## DEVIATION REQUEST AND DECISION FORM

### PROJECT INFORMATION – MAYBERRY DRIVE DEVIATION REQUEST

Project Name : Mayberry, Colorado Springs Filing No. 1  
Schedule No.(s) : 34000-00-259, -260, -349, -350, -356, -362  
Legal Description : Mayberry, Colorado Springs Filing No. 1

### TYPICAL ROAD SECTIONS

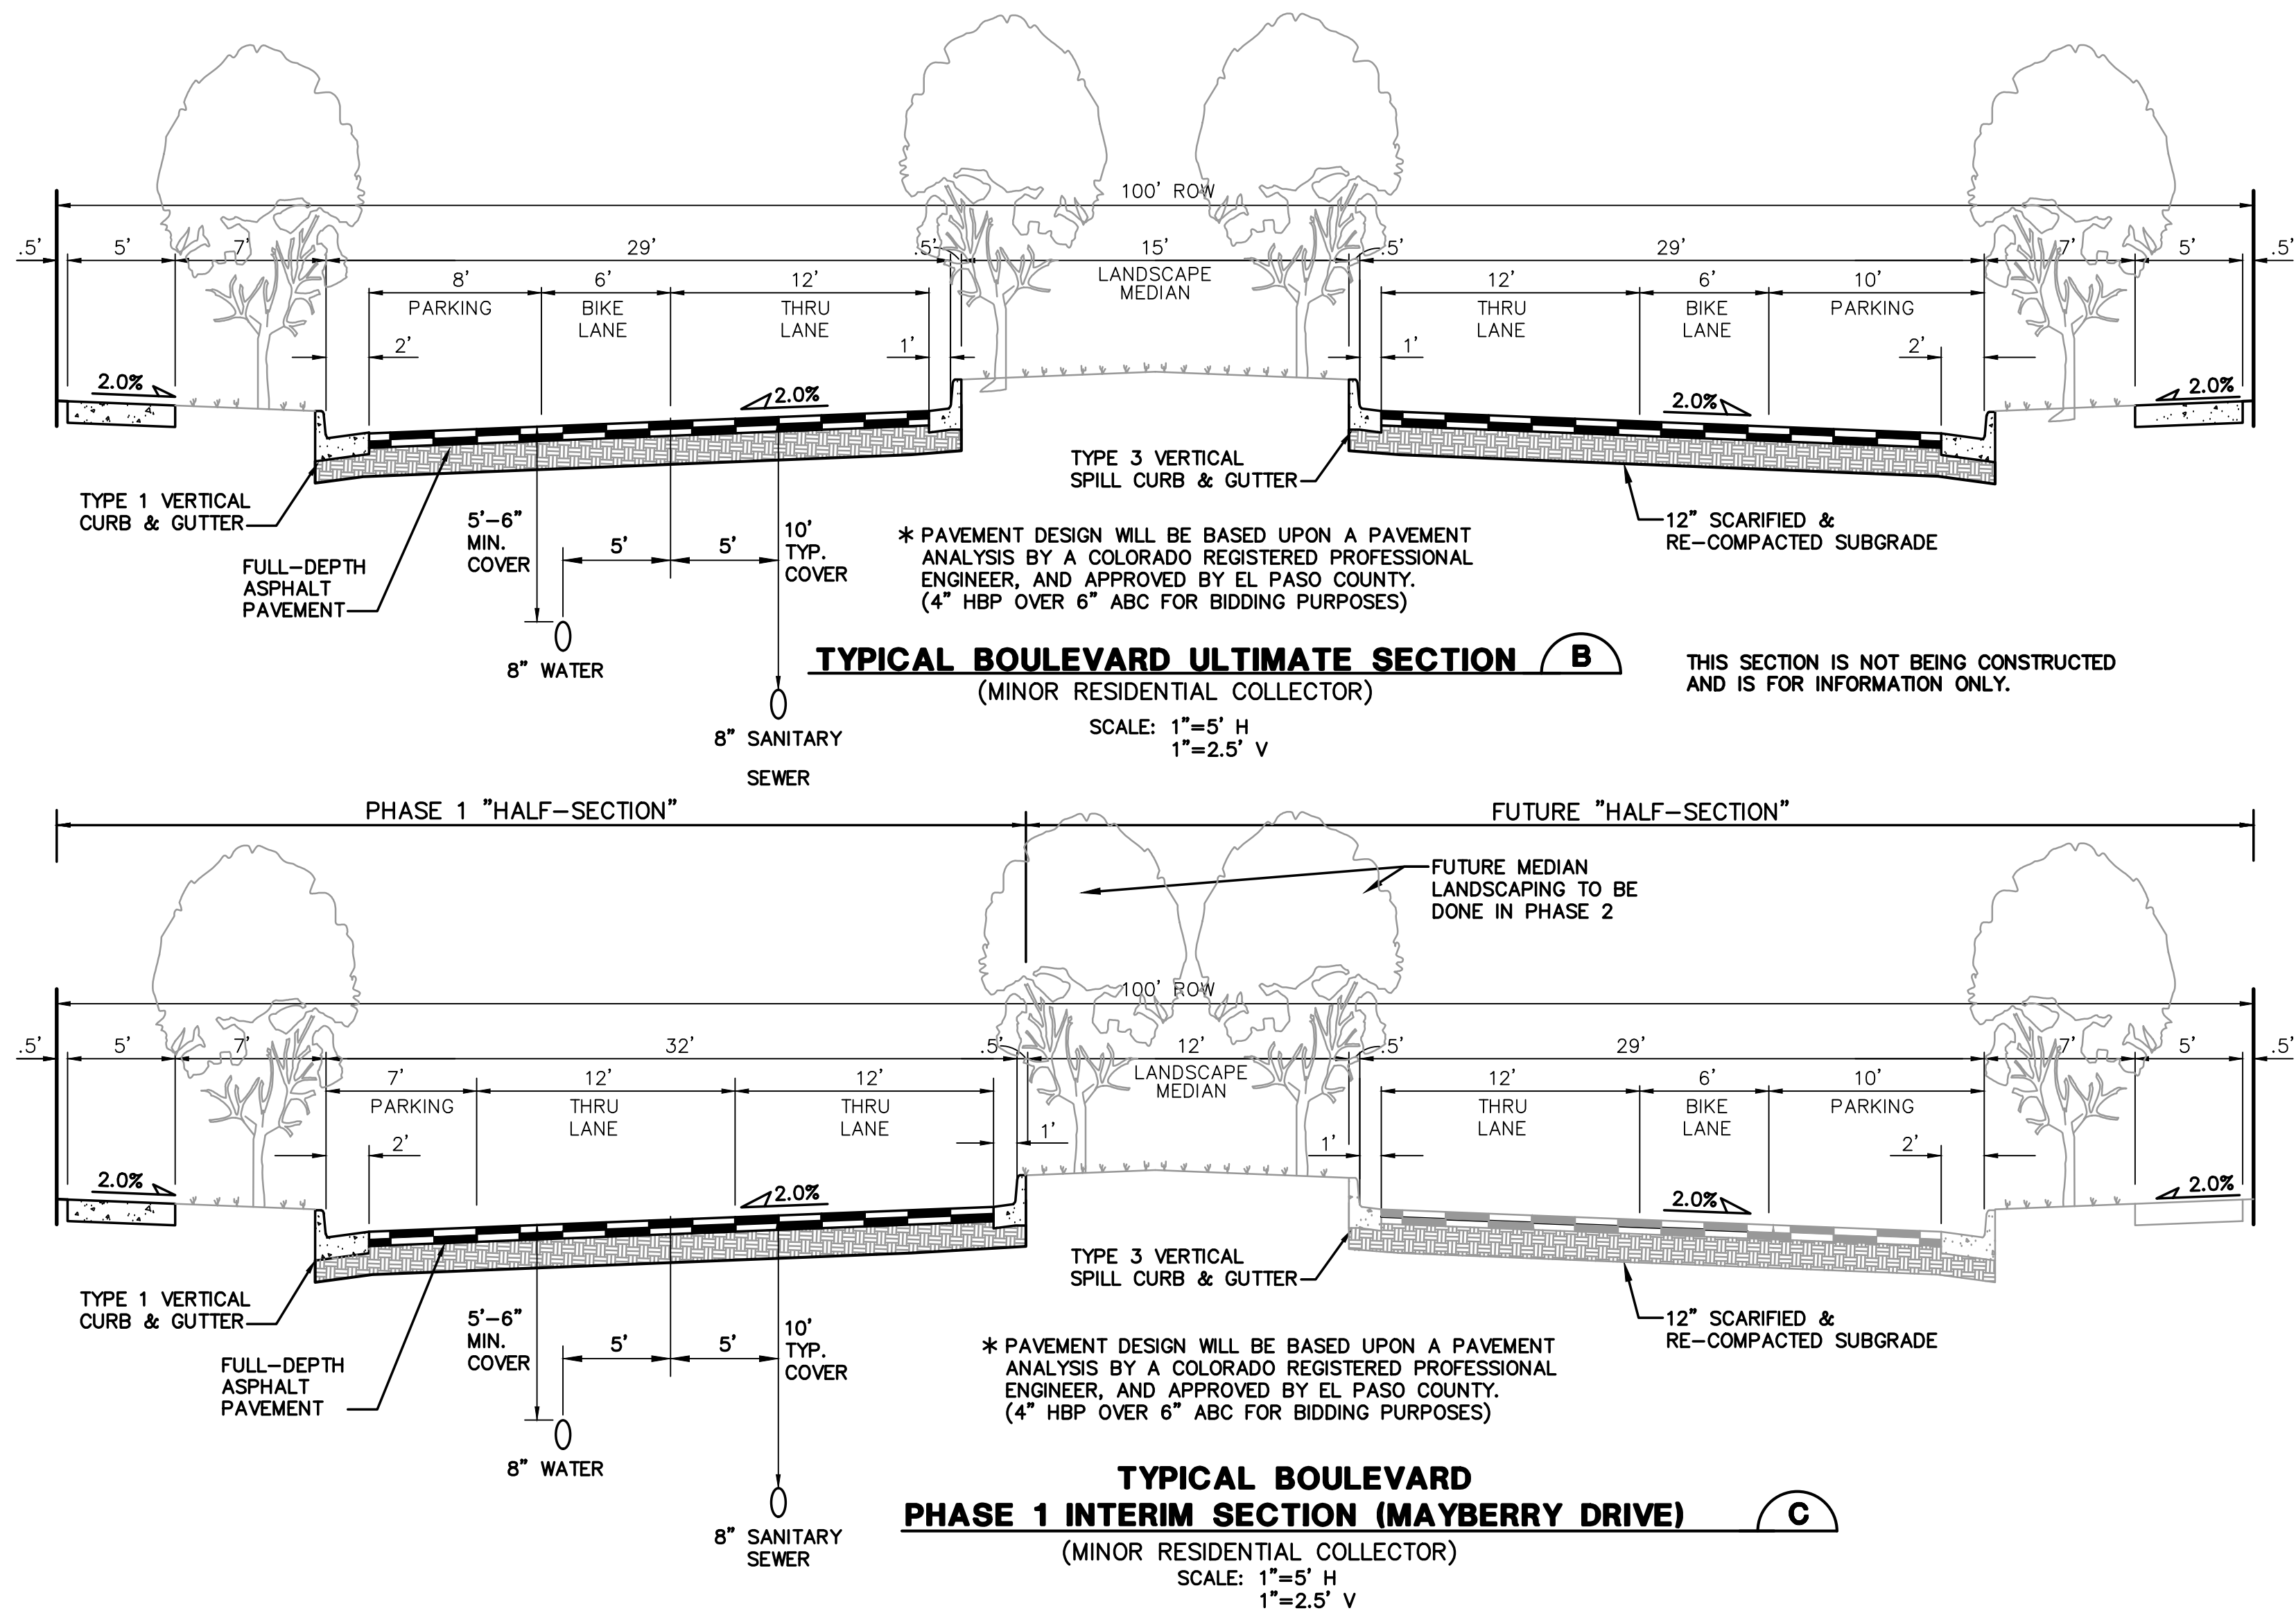
Please clarify what the difference is between the phase 1 half section and the ultimate section, where it loses 3' of asphalt?
